CITY OF ALBUQUERQUE

**RE: Guardian Storage- Juan Tabo
4909 Juan Tabo NE
Conceptual Grading and Drainage Plan Stamp Date: none
Hydrology File: F21D081**

Based on the submittal received on 11/12/19, the Conceptual Grading and Drainage Plan cannot be approved until the following are corrected:

SHEET NUMBER: C-101

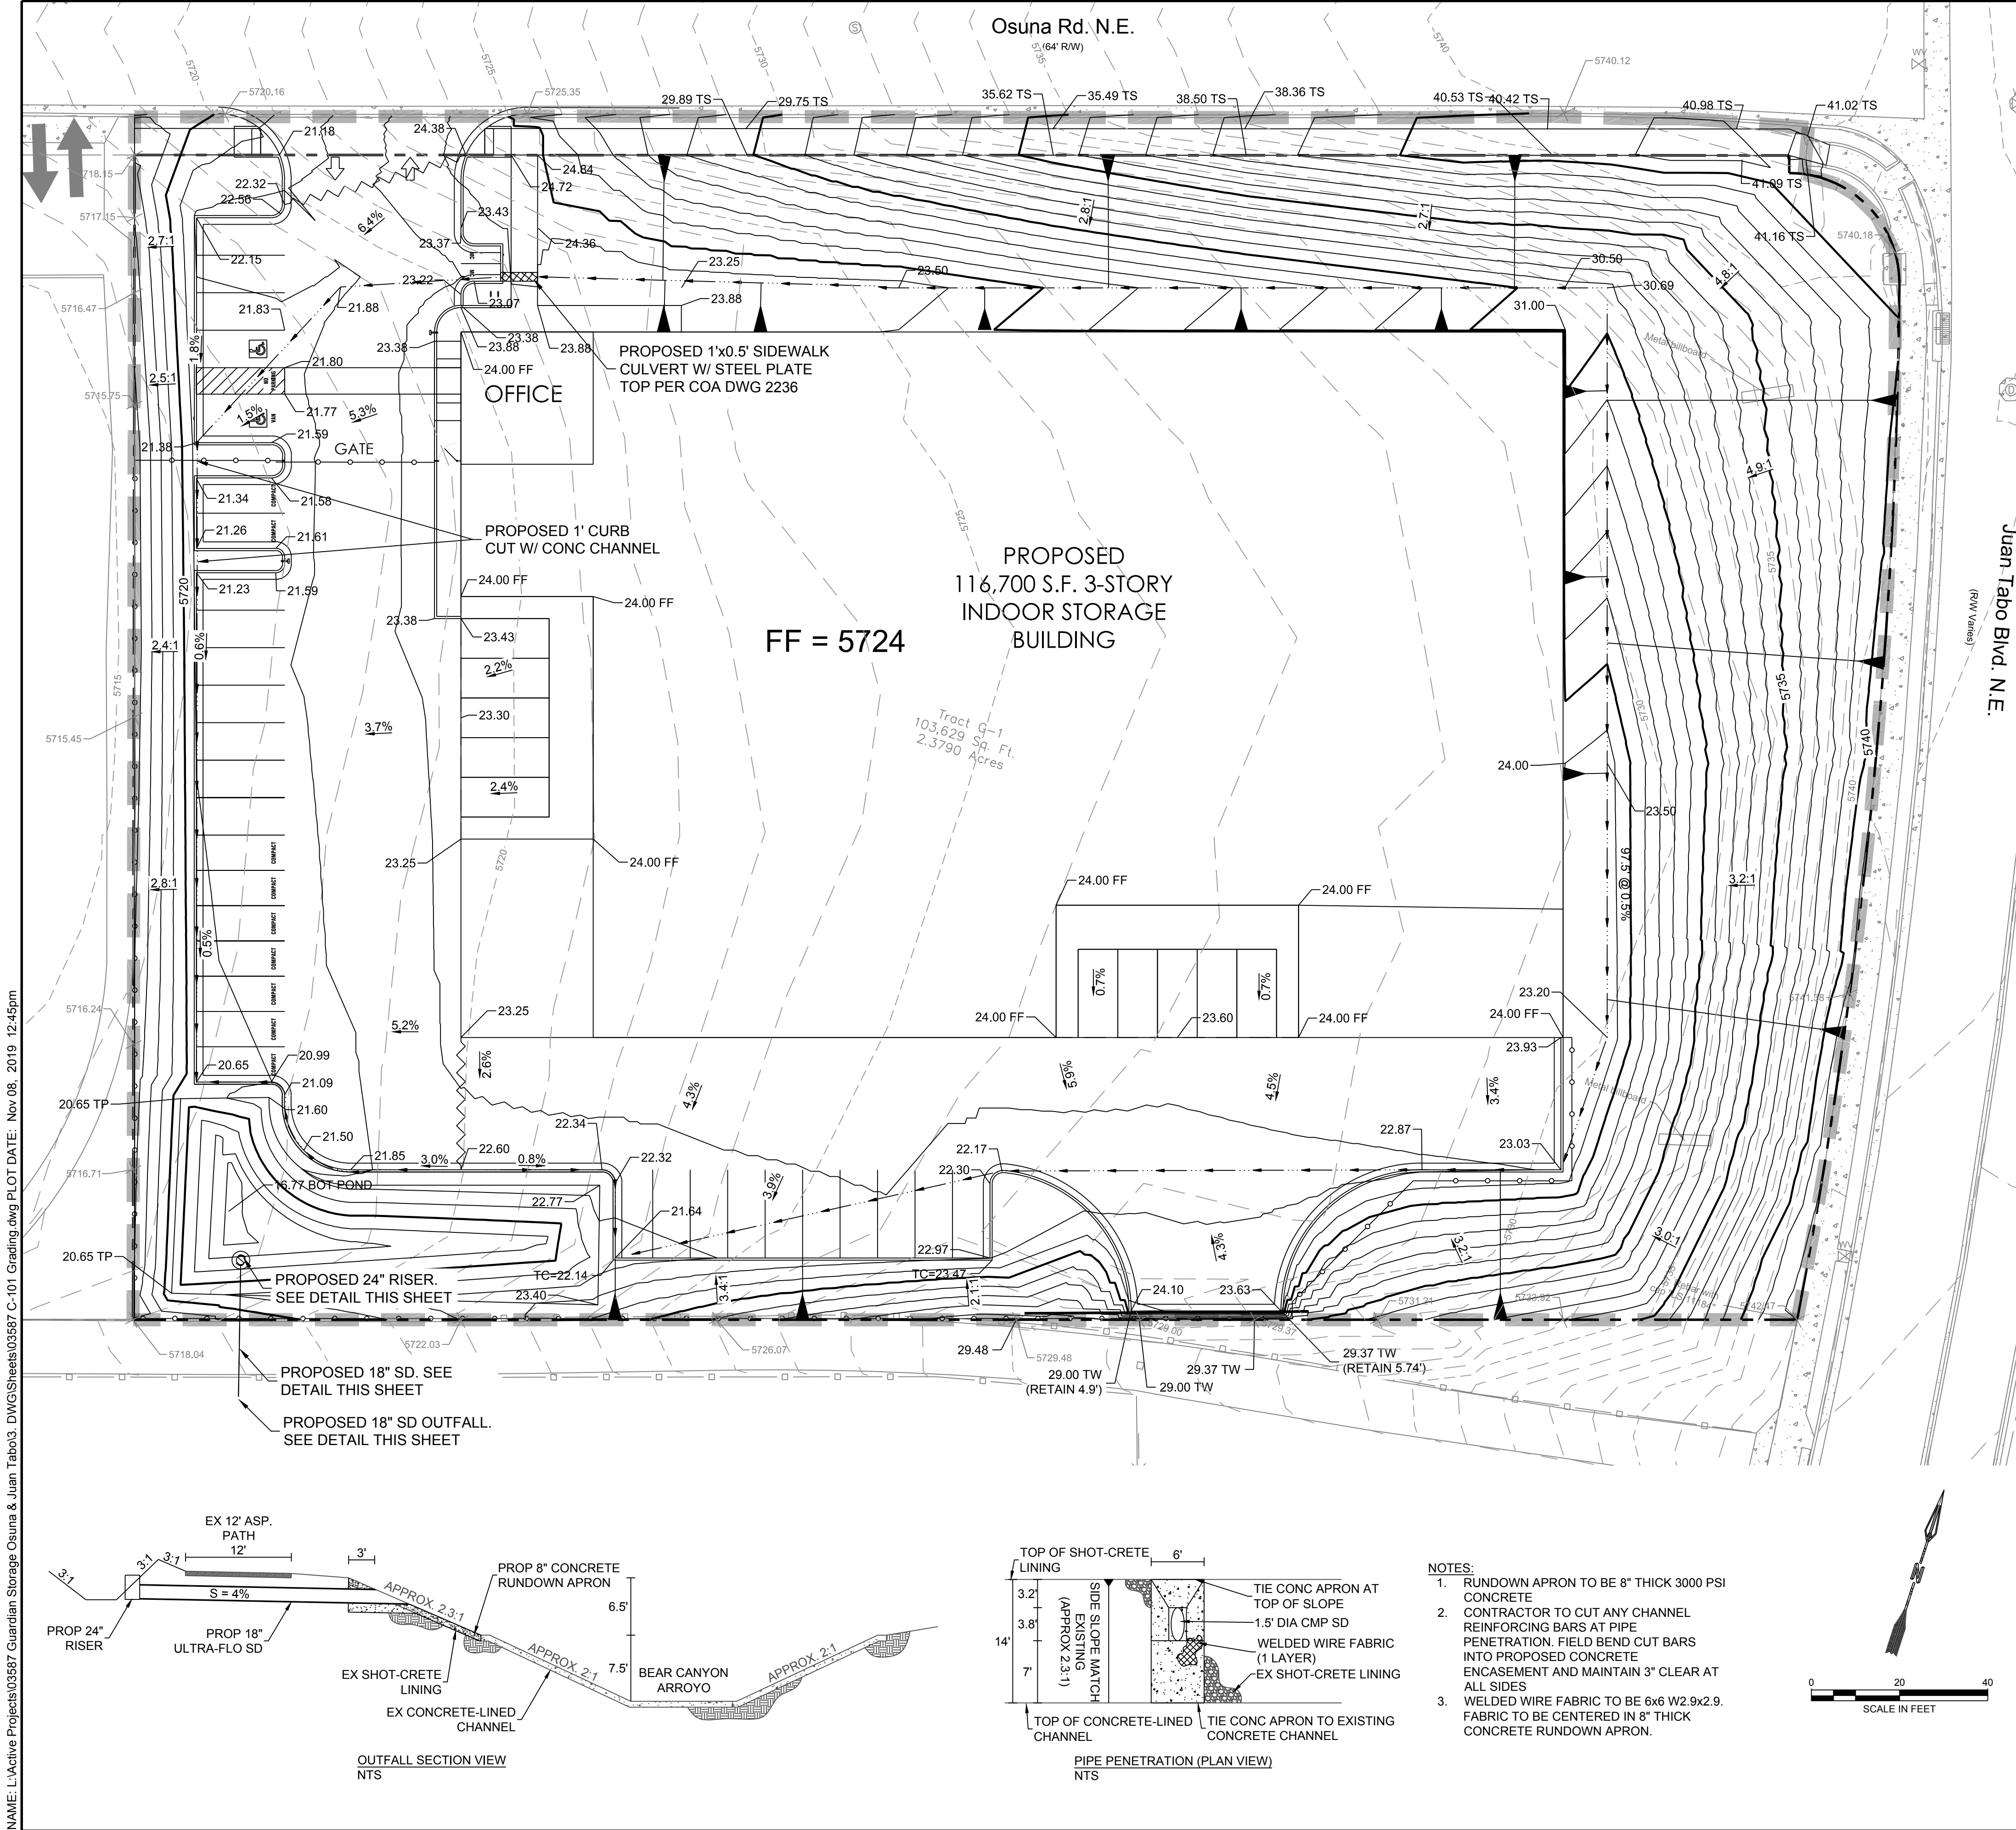
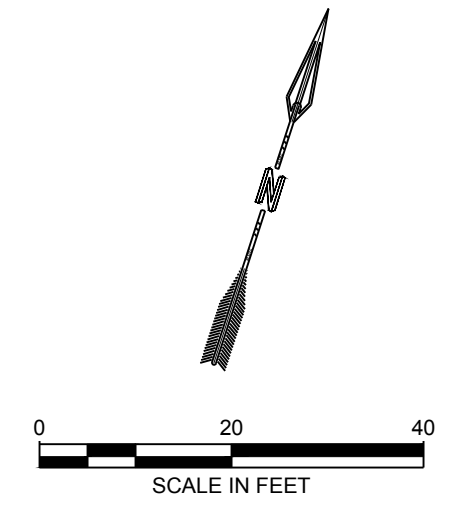
1. Please provide an engineer's stamp with a signature and date.
2. Provide written and signed permission for the proposed cross lot drainage onto the adjoining property to the west. If there's a cross-lot drainage easement for this discharge, please provide it.

3. The discharge to Bear Canyon Arroyo shall be by City Work Order using an RCP pipe penetration into the standard concrete portion of the channel, per AMAFCA Standard Detail 103 or 104. This work needs to be included on the infrastructure list.

4. Provide slope easements (3:1) from the edge of ROW/PL down to the proposed grade along Juan Tabo, Osuna, and the arroyo.
5. Provide slope protection anywhere slopes exceed 3:1.

6. Provide an emergency spillway (or 2x capacity on the outfall), sized for the 100-yr peak inflow on the proposed pond. The spillway must be directed to the arroyo easement, not the property to the west.

7. Provide a waterblock, 0.87' high at the drive entrance. Alternatively, provide flow depth (and EGL) calculations along Osuna to justify a lesser waterblock.

8. Provide sections through all external boundaries, especially the retaining wall adjacent to the arroyo, showing proposed retaining walls, garden walls, property/ROW lines, existing and proposed grades. In accordance with DPM Ch.22, section 5 part B, grading and wall construction near the property line may not endanger adjacent property or constrain its use.
9. Only one paper copy (plus the pdf) is required for Hydrology submittals.
